Mr Ray Fung, Director Engineering and Transportation
District of West Vancouver,
750 17th Street
West Vancouver
V7V 3T3 BC

June 14, 2019

Re: Proposed changes to Spirit Trail Multi Use Path & Welch Street Roadway

Figure 6 Spirit Trail near Pemberton Ave, North Vancouver (looking east) – existing baffle gate as modified by DNV to permit traverse by larger vehicles.

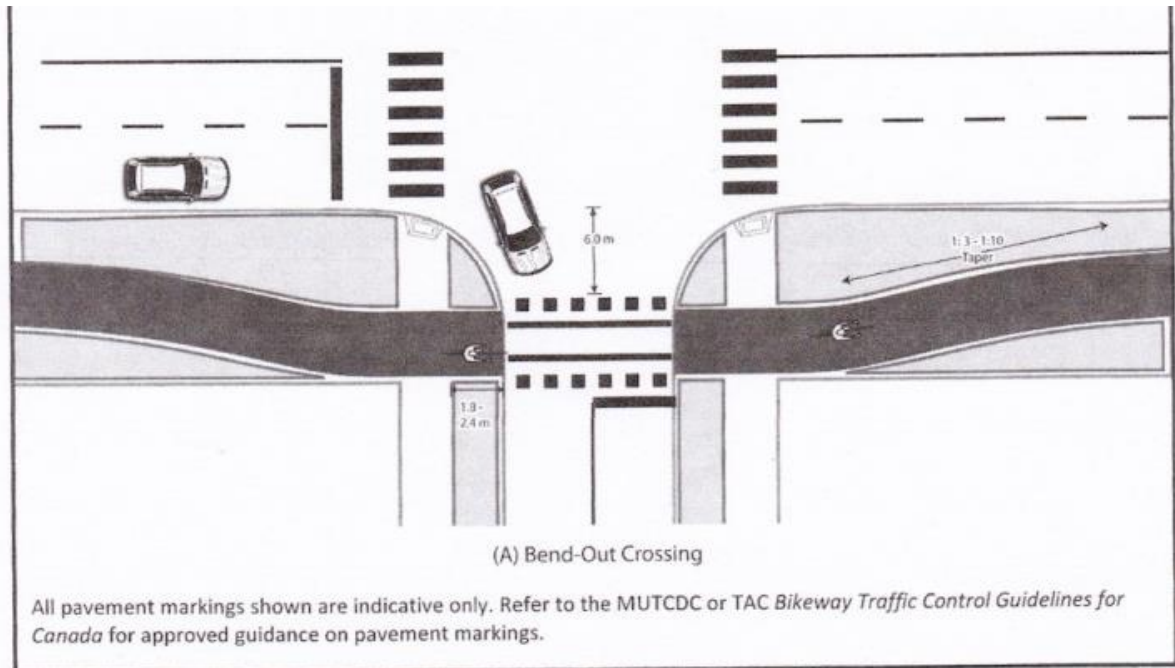
3. Spirit Trail Alterations: We are supportive of slow zones and generally lower cycling speeds on the multi-use path, but strongly advise against installing baffles. The proposed baffles on the path at the intersection approaches may decrease cycling speeds close to the baffle, but create several other hazards for all users. Baffle gates should not be used on paths to divert or slow path traffic, even if marked and lit. Baffles constitute a serious hazard to cyclists and reduce accessibility².

² The District of North Vancouver installed a baffle gate on the Spirit Trail near Pemberton Street (see Attachment 2, Figure 6). The baffle has increased the risk of falls, collisions and injuries. Older and very young cyclists as well as people who ride infrequently can lose balance while negotiating the baffle or they collide with other path users. The baffle makes path access difficult or impossible for some users, such as people with child trailers, trail-a-bikes, tricycles, tandem bikes or double strollers. Baffles also create bottlenecks and frustrate users, especially those travelling in groups, since only one person at a time can pass through (at Pemberton Street people simply walk or bike on the road around the baffle).
